Addendum No. 2 -- 2483 To IMPACTED MATERIALS PLACEMENT PLAN ON-SITE DISPOSAL FACILITY

Specialized Placement Plan for Thorium Impacted Debris

20100-PL-007 Revision A August 1999

Fernald Environmental Management Project Fernald, Ohio

FIGURE 4
THORIUM IMPACTED DEBRIS PLACEMENT
OPTION 2 - TRENCHING METHOD 12
SHEET 1 OF 1

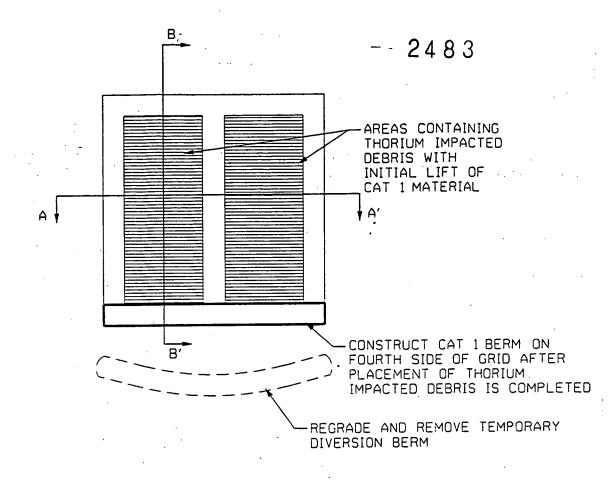
Trench Excavation: After a grid(s) is selected and approved, a trench (or trenches) shall be excavated as shown on Figure 4. Each trench shall be a minimum of 3 ft (0.9 m) deep and a maximum of 4 ft (1.2 m) deep and between 8 ft (2.4 m) and 12 ft (3.6 m) wide. A minimum 6 ft (1.8 m) distance shall be maintained between top of the side slopes of the adjacent trench. One end of the trench shall be graded to a minimum 5H:1V ramp (subject to approval by FDF Safety Engineer) for truck access into the trench. The trench bottom shall be graded at an approximately 1% slope downward away from the truck access ramp. The maximum trench length shall be approximately 70 ft (21 m) and shall be limited by the maximum length that can be excavated in one grid and still provide adequate access to enter and exit the trench. The Category 1 material excavated from the trench shall be stockpiled a minimum of 6 ft (1.8 m) from the top of the side slopes of the trench and shall be used later for initial and additional lifts over the thorium impacted debris. The necessary radiological controls will be established prior to commencement of thorium impacted debris placement.

Initial and Additional Lifts of Category 1 Material: After thorium impacted debris is placed in the trench and compacted, it shall be covered with an initial 15 inches (375 mm) ±3 inches (75 mm) loose lift of Category 1 material by the end of each working day. The initial lift shall be compacted with a minimum of four one-way passes of a self-propelled double drum roller compactor, a smooth drum vibratory roller or other compaction equipment approved by the Construction Manager. No compaction testing will be performed on the initial lift above the thorium impacted debris. An additional 12 inches (300 mm) ±3 inches (75 mm) loose lift(s) of Category 1 material shall be placed above the initial lift. Total compacted thickness of Category 1 material placed above the thorium impacted debris, including the initial lift, shall be a minimum 15 inches (375 mm) as shown on attached Figure 4. The Category 1 lift(s) above the initial lift shall be compacted to meet at least 90 percent of the standard Proctor maximum dry density. Compaction of the additional lift(s) shall be tested in accordance with the IMP Plan. Category 1 material shall subsequently be placed in accordance with the IMP Plan to a minimum thickness of 2 ft (0.6m) or the intervening horizon as described in the IMP Plan, whichever is greater; as shown on Figure 4.

FIGURE 2
THORIUM IMPACTED DEBRIS PLACEMENT
OPTION 1 - GRID METHOD
PLAN VIEW /D
SHEET 2 OF 3

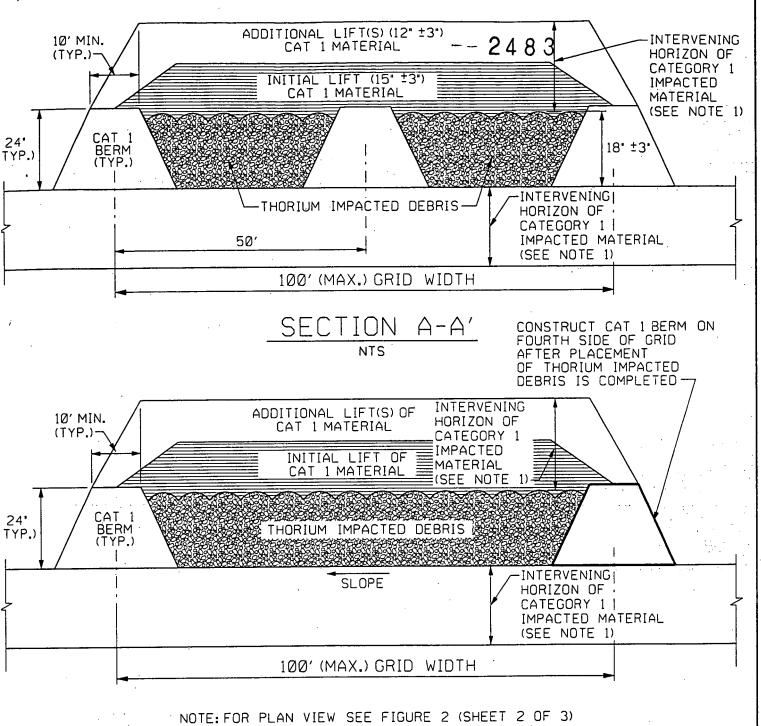
Preparation of the Grid: After a grid is selected and approved, perimeter berms shall be constructed on three sides of the grid, as shown on Figure 1. These berms shall be constructed from Category 1 material; they shall be 24 in (600 mm) high and have a minimum top width of 10 ft (3 m). The berms shall be placed and compacted in 12 inch (300 mm) to 15 inch (375 mm) loose lifts in accordance with the IMP Plan. An additional berm shall be constructed (with the same requirements of the perimeter berms) in the middle of the grid to provide access for a trackhoe (or other equipment) to spread and compact the debris. Until thorium impacted debris placement in the grid is complete, the fourth side shall be left open for truck entrance and exit to and from the grid. The fourth side of the perimeter berm shall be constructed after completion of thorium impacted debris as shown in Figures 2, and 3. The berms shall be compacted to meet at least 90 percent of the standard Proctor maximum dry density as described in the IMP Plan (Section 7.4.2). Compaction shall be tested in accordance with the IMP Plan. The surface of the Category 1 material on which the thorium impacted debris will be placed shall be graded at an approximately 1% slope downward away from the truck entrance and exit

side of the grid. A temporary diversion berm (approx. 18 inches [450 mm] high) shall be constructed approximately 30 ft (9 m) in front of the grid entrance to limit runoff from entering the grid. The grid shall be oriented so that the open side of the grid (fourth perimeter berm) is at the up gradient side of the grid. The required radiological controls for the placement area will be established prior to commencement of thorium impacted debris placement.

Debris Placement: After the grid has been prepared, trucks transporting thorium impacted debris shall dump material at the down gradient end of the grid. Thorium impacted debris shall be spread and tamped by the bucket of a trackhoe (or with an optional tamping plate attachment) to achieve a maximum loose lift thickness of 18 inches (450 mm) ± 3 inches (75 mm). The trackhoe shall be of sufficient size and reach and be situated in such a way that only the bucket (and tamping plate attachment) shall contact the thorium impacted debris. Compaction, other than tamping from a trackhoe bucket (and tamping plate attachment), shall not be performed directly on the thorium impacted debris. In accordance with the ALARA concept, equipment operators and other personnel shall avoid contact with thorium impacted debris. Also, trucks delivering thorium impacted debris shall not drive on material deposited by the trucks or previously placed thorium impacted debris to minimize the potential for thorium contamination on the outside of the vehicle. A radiological technician will monitor the trucks at the exit to the grid as shown on Figure 1. Fugitive dust and storm water runoff controls shall be in accordance with the IMP Plan. Water trucks and/or water hoses shall be available at the location of placement activities.

FIGURE 3 THORIUM IMPACTED DEBRIS PLACEMENT OPTION 1 - GRID METHOD CROSS SECTIONS 3 OF-- 3 flaures.don

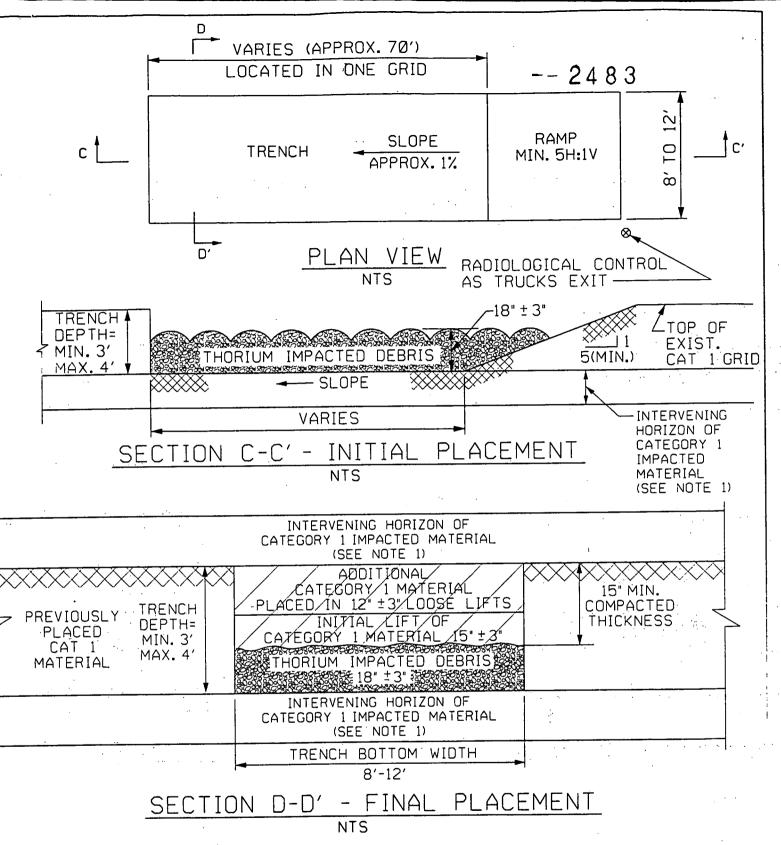
Initial and Additional Lifts of Category 1 Material: As the debris placement progresses, an initial 15 inches (375 mm) ± 3 inches (75 mm) loose lift of Category 1 material (soil and soil-like material) shall then be placed on top of the thorium impacted debris by the end of each working day. The initial lift shall be compacted with a minimum of four one-way passes of a self-propelled double drum roller compactor, a smooth drum vibratory roller or other compaction equipment approved by the Construction Manager. No compaction testing will be performed on the initial lift above the thorium impacted debris. As shown in Figures 2 and 3, the fourth side of the perimeter berm will be constructed after thorium impacted debris placement is completed. After the fourth side of the perimeter berm has been placed and initial lift is placed over the thorium contaminated debris, the temporary diversion berm to control storm water runoff shall be removed. An additional 12 inches (300 mm) ± 3 inches (75 mm) loose lift(s) of Category 1 material shall be placed above

the initial lift. Total compacted thickness of Category 1 material placed above the thorium impacted debris, including the initial lift, shall be minimum 2 ft (0.6m) or at least as thick as the intervening horizon described in the IMP, whichever is greater. See attached Figure 3. The Category 1 lift(s) above the initial lift shall be compacted to meet at least 90 percent of the standard Proctor maximum dry density. Compaction of the additional lift(s) shall be tested in accordance with the IMP Plan.
